Meeting Date:
May 15, 2025

Location:
41 E. Main Street

Request
Variance requests to
construct an addition

Case Manager:
Lauren Coffman,
Associate Planner

3 SOUTH ELEVATION
 SCALE: 1/4" = 1'-0"

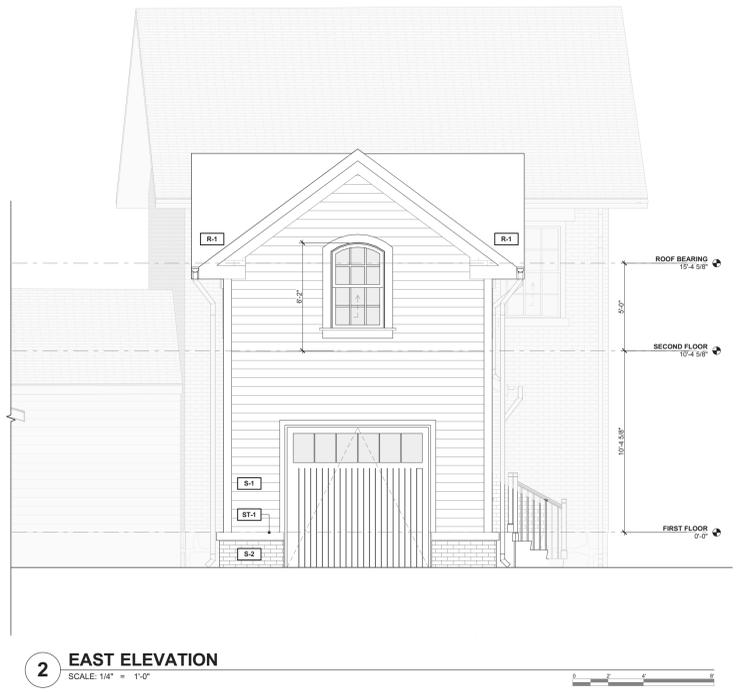
- Staff notes that the proposed addition would be two stories. However, staff notes that the twenty-three (23) foot roofline of the addition would be subordinate to the main mass of the structure which sits at approximately thirty-two (32) feet.

- Question if the southern facing dormer could be removed to reduce overall massing and impact to the adjacent property.
- 4. Whether the variance would adversely affect the delivery of governmental services such as water and sewer:**
The variance would not impact the delivery of governmental services such as sewer and water.
